## PROPOSED HIGH-RISE MIXED-USE DEVELOPMENT 1950 Scott Street and 312 & 314 Clifton Road

Development Servicing Study and Stormwater Management Report

**Markup for ZBLA Submission September 16th, 2024  
(See Accompanying Memorandum for Details)**

Ref: R-2024-087  
Novatech File No. 121301

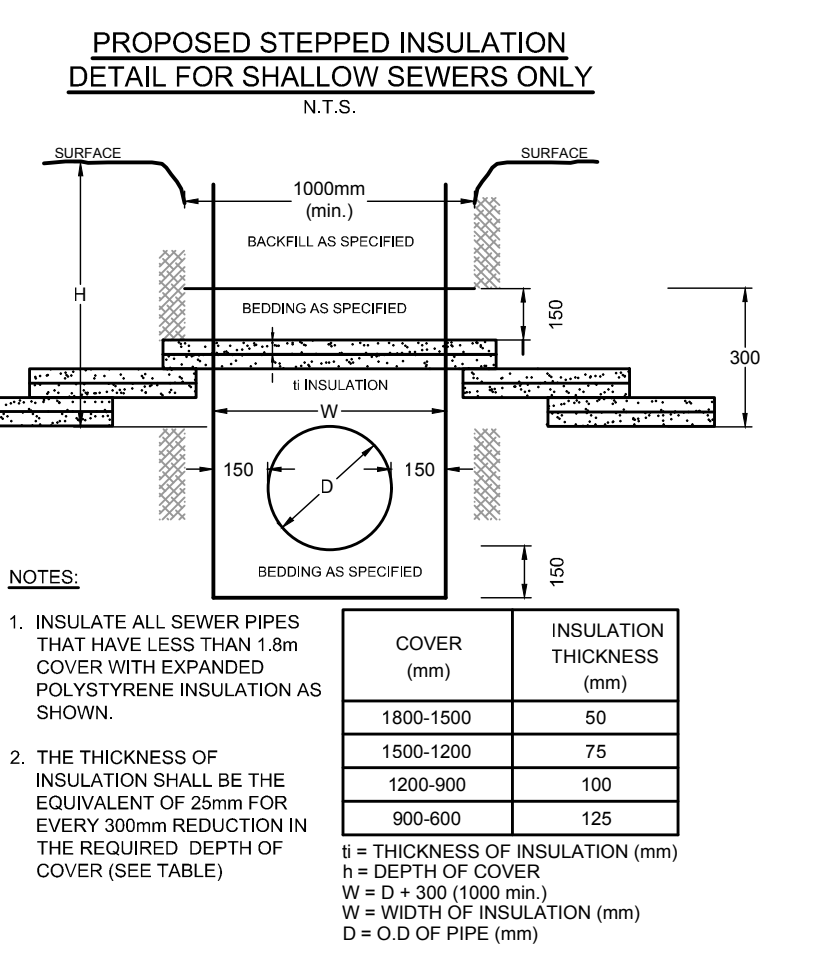
Entrance to UG parking to be shifted north to accommodate loading area along property line as per updated architectural Site Plan. Grading and SWM designs to be revised accordingly at SPC re-submission stage.

**POST-DEVELOPMENT CONDITIONS**

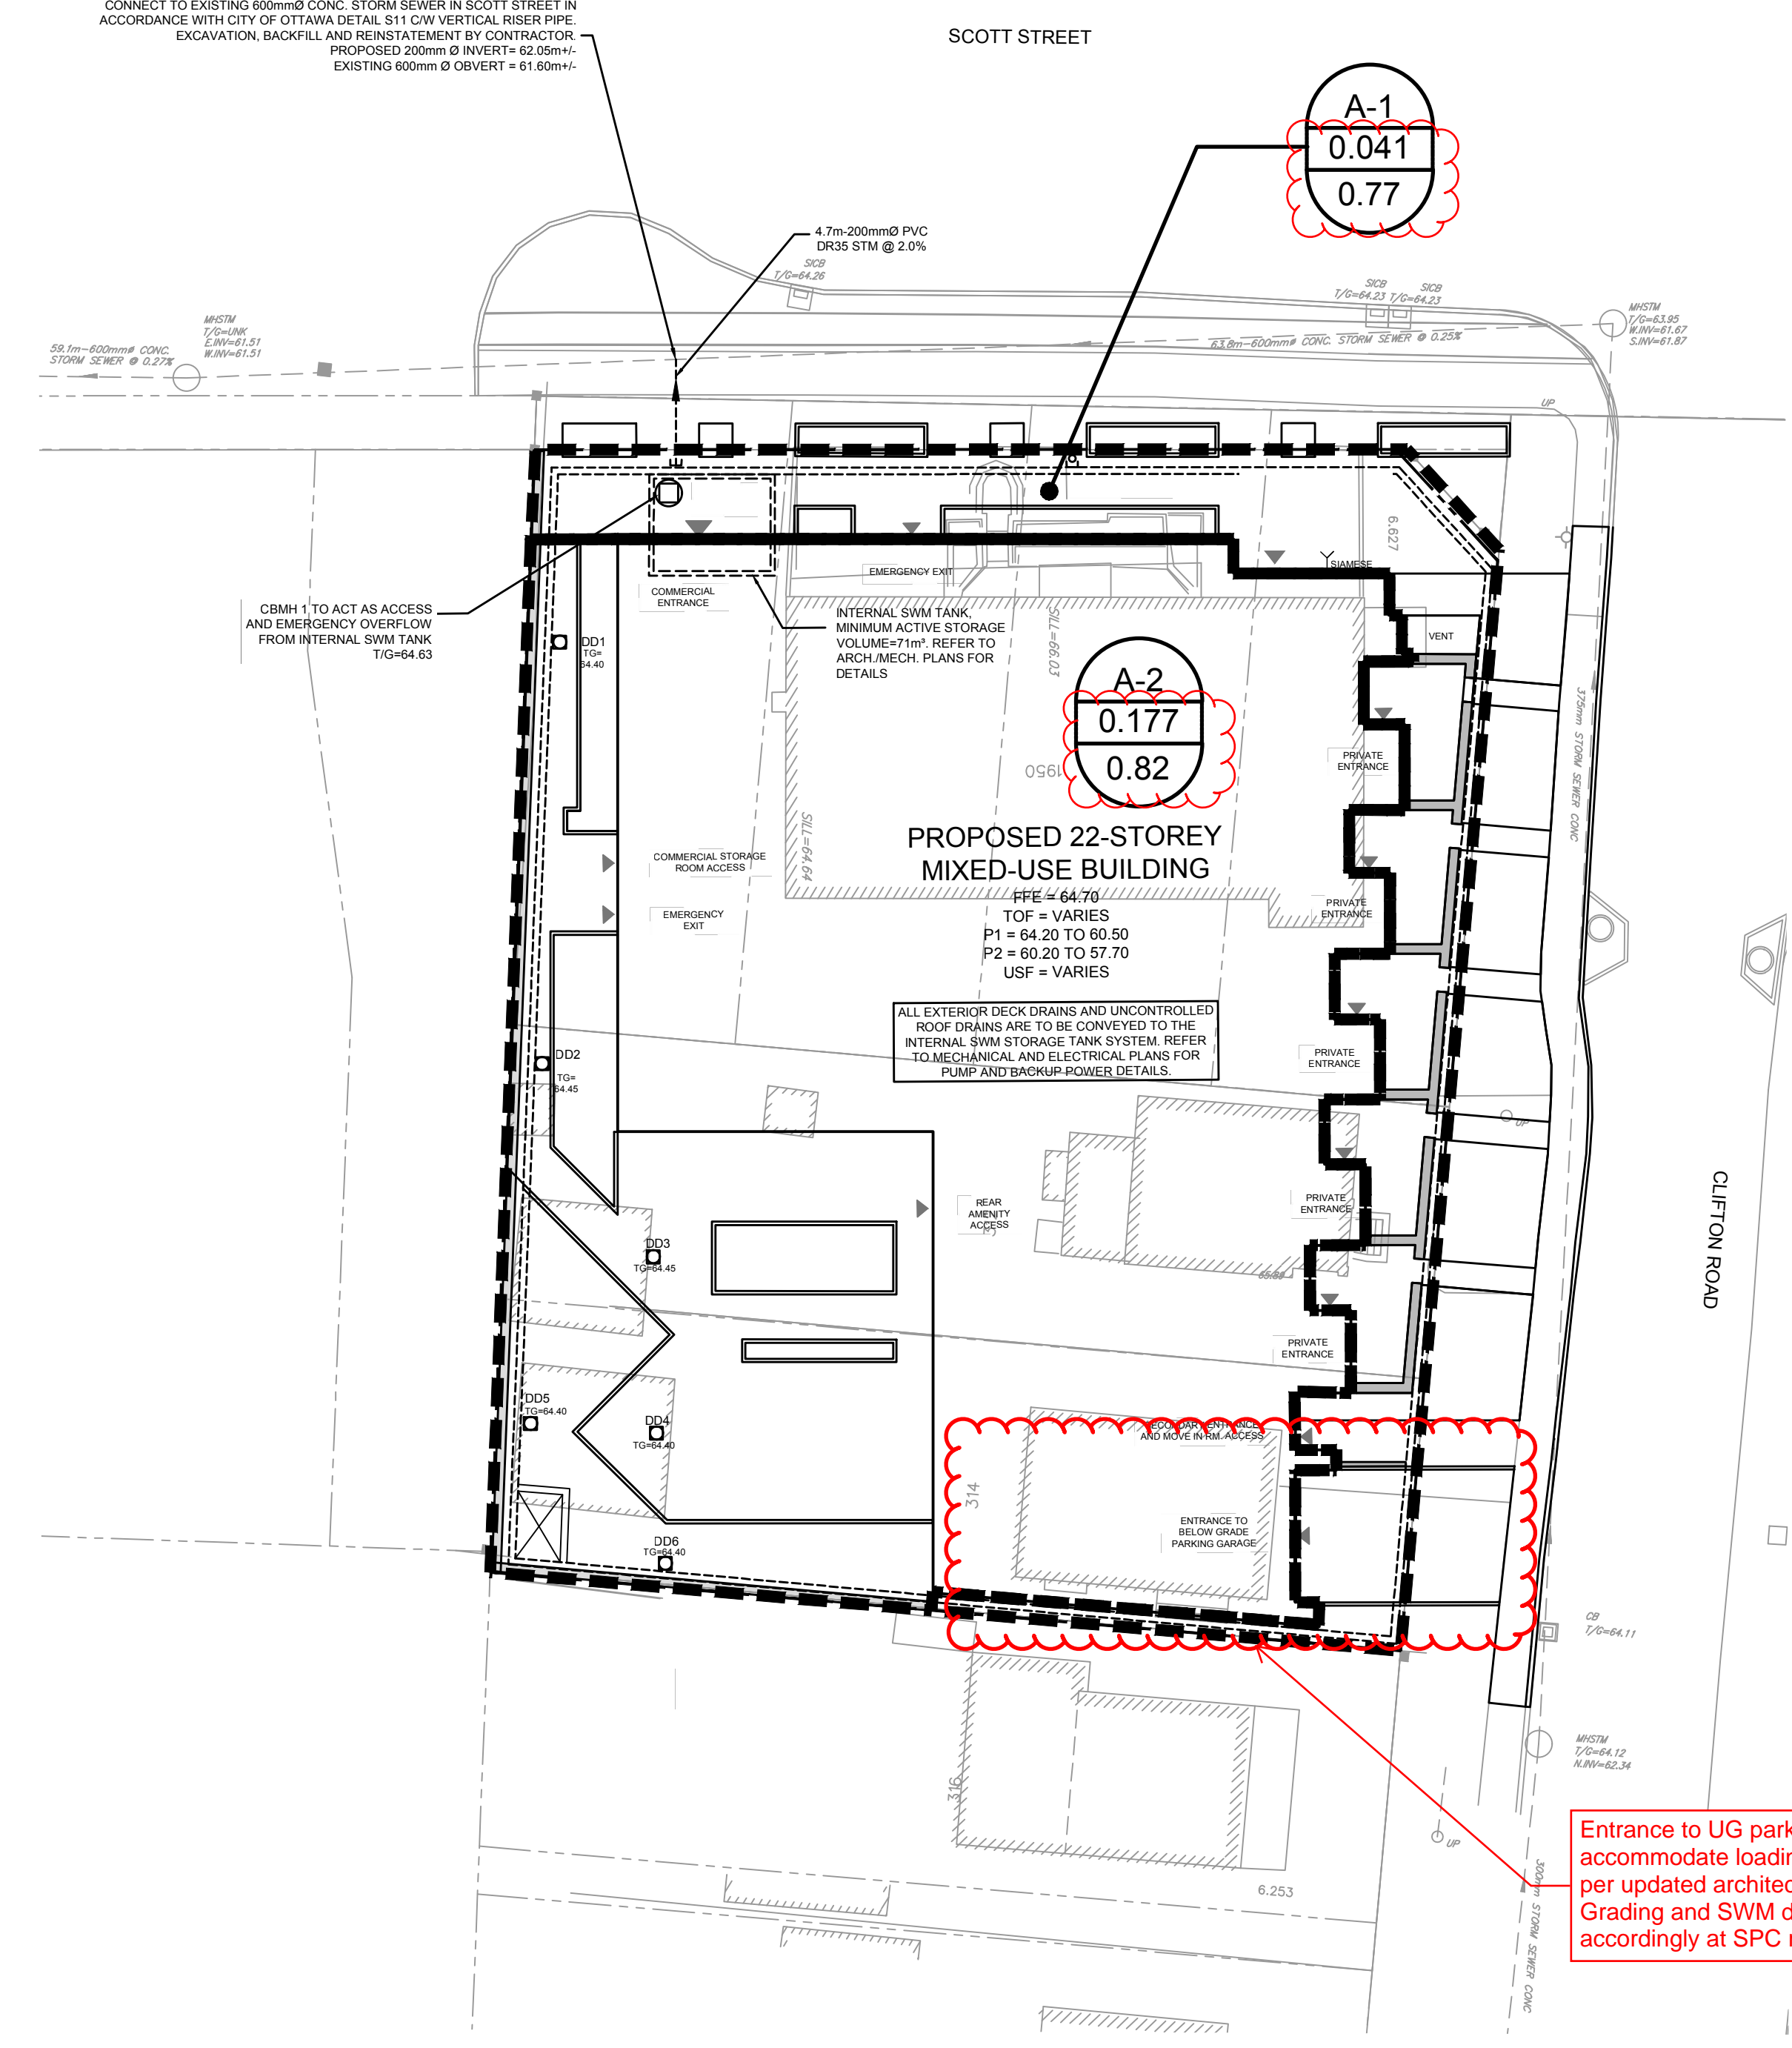
Post-Development drainage areas and 1.5 year weighted runoff coefficients may be updated based on shifted UG Parking access and loading area.

Internal SWM Cistern Pumped Flow Rate and Storage Volumes may be updated based on shifted UG Parking access and loading area.
